**SUBJECT: REVISION "B" TO TECHNICAL BULLETIN 407-07-75:
FADEC ECU EMC-35 WITH REVERSIONARY GOVERNOR,
INTRODUCTION OF.**

No. 407-07-75

SUBJECT: FADEC ECU EMC-35R WITH REVERSIONARY GOVERNOR, INTRODUCTION AND INSTALLATION OF.

FIGURE 1. ECU installation

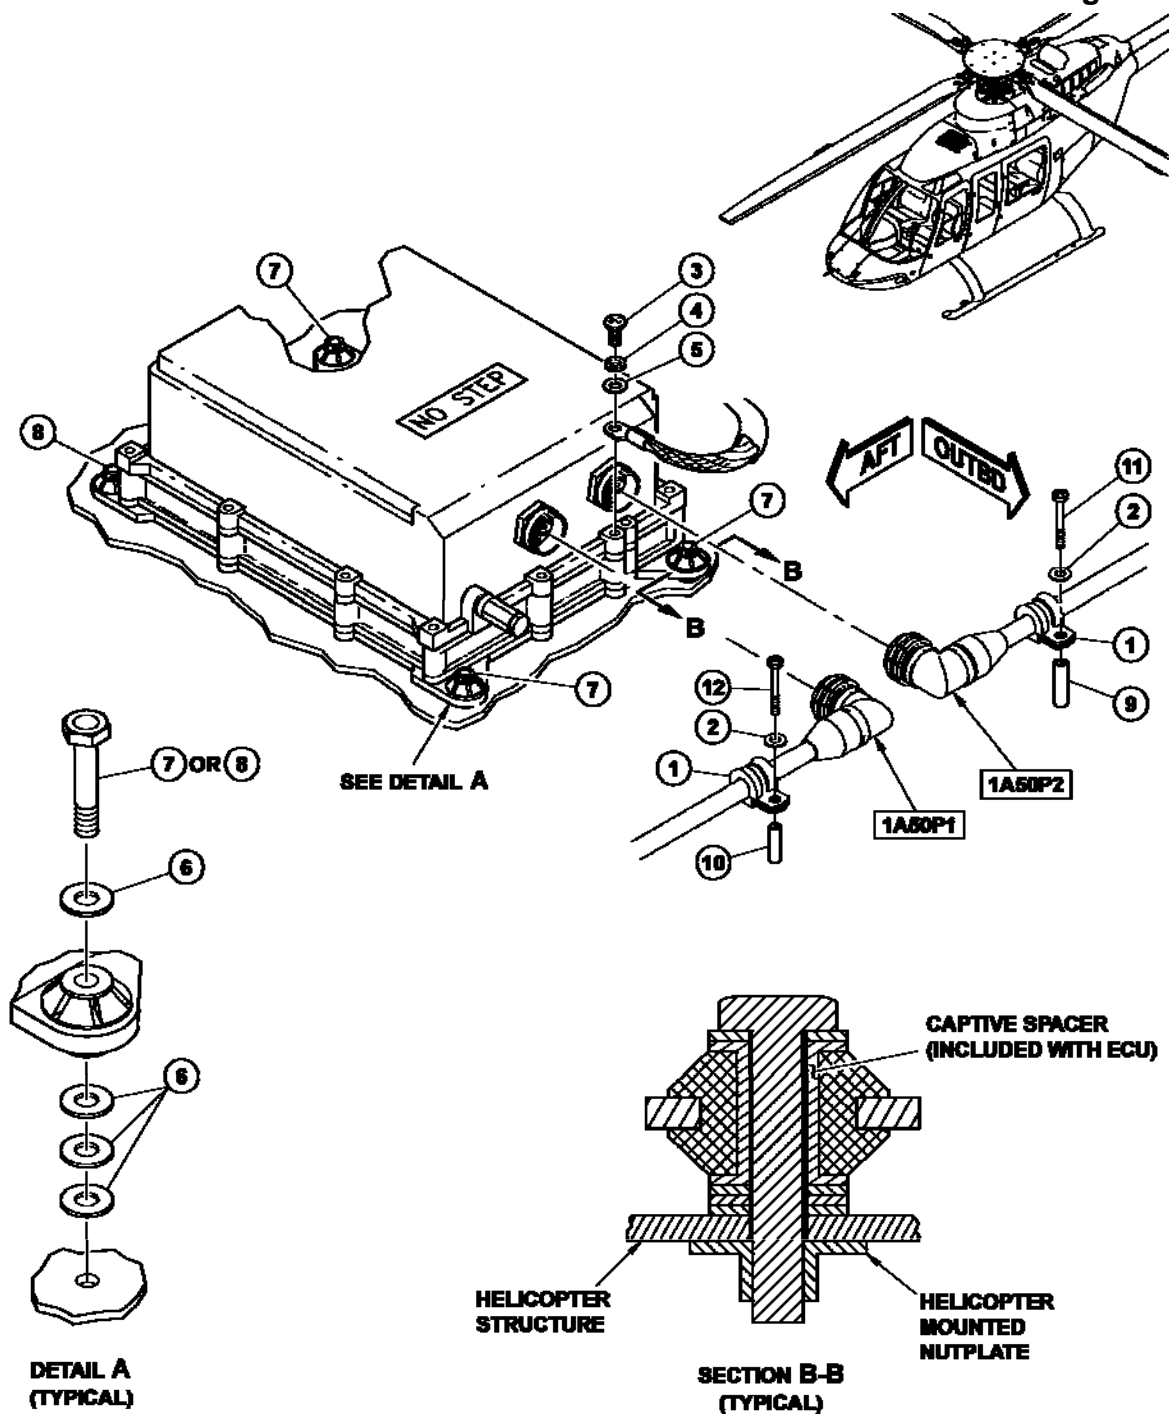
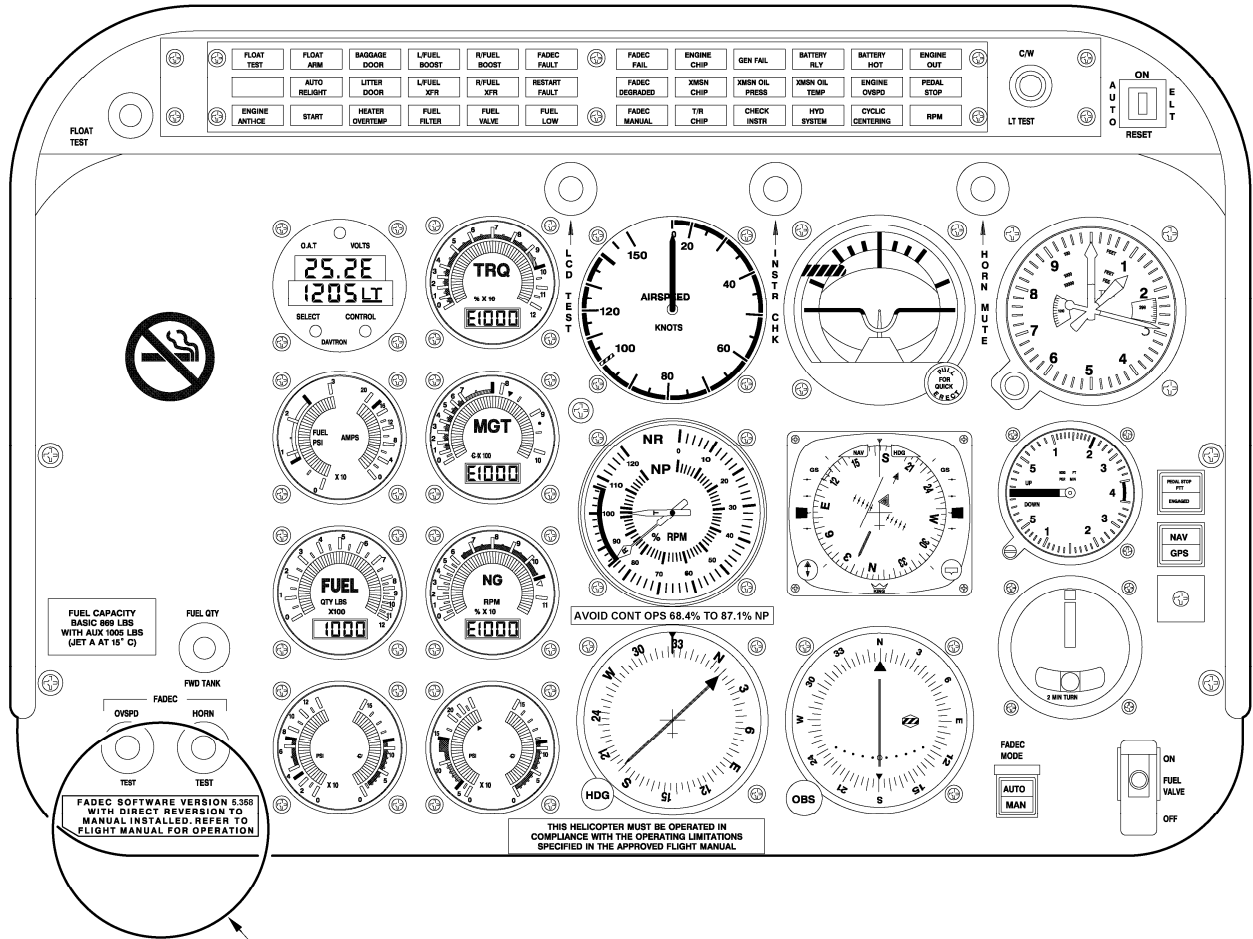
4. Disconnect clamps (1) currently holding the cable assemblies 407-375-012-101 (or 407-076-503-111) and 407-375-012-103 (or 407-076-503-109) to the roof deck that are adjacent to the ECU connectors 1A50P1 and 1A50P2. Refer to Figure 1.
5. Disconnect the FADEC harness electrical connectors 1A50P1 and 1A50P2 from the ECU.
6. Remove the screw (3), lock washer (4), washer (5) and the bonding strap from the ECU. Retain hardware.

7. Remove bolts, washers (6) and spacers holding the ECU to the deck.
8. Remove ECU P/N 23072790.
9. Install ECU P/N 23088484 using hardware as shown in Figure 1.

10. Re-install bonding strap using screw (3), lock washer (4), washer (5) onto the ECU.
11. Ensure connectors 1A50P1 and 1A50P2 are clean and in a serviceable condition and install to the ECU. If applicable, re-install clamp (1) and washers (2), removed in Step 4, and spacers (9 and 10). Refer to Figure 1

Figure 2. Instrument Panel Decal Location

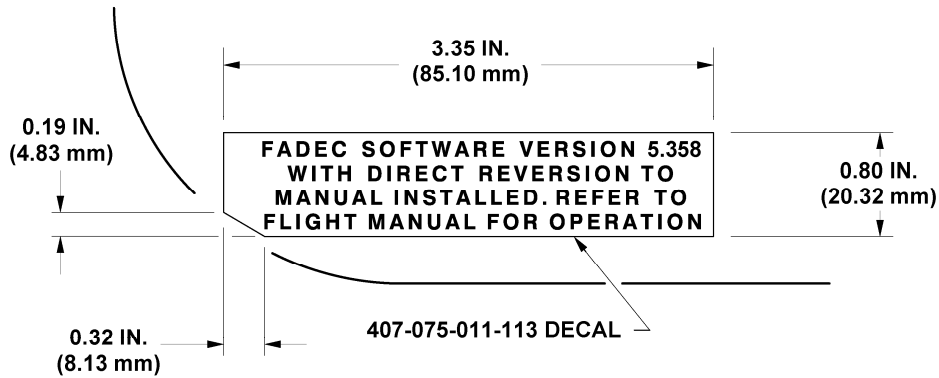
13. Install decal 407-075-011-113 on instrument panel. Refer to Figure 2.
14. Seal edges of decal using edge sealer (C-349).
15. Re-install all cowlings previously removed (BHT-407-MM, Chapter 53 – Fuselage).
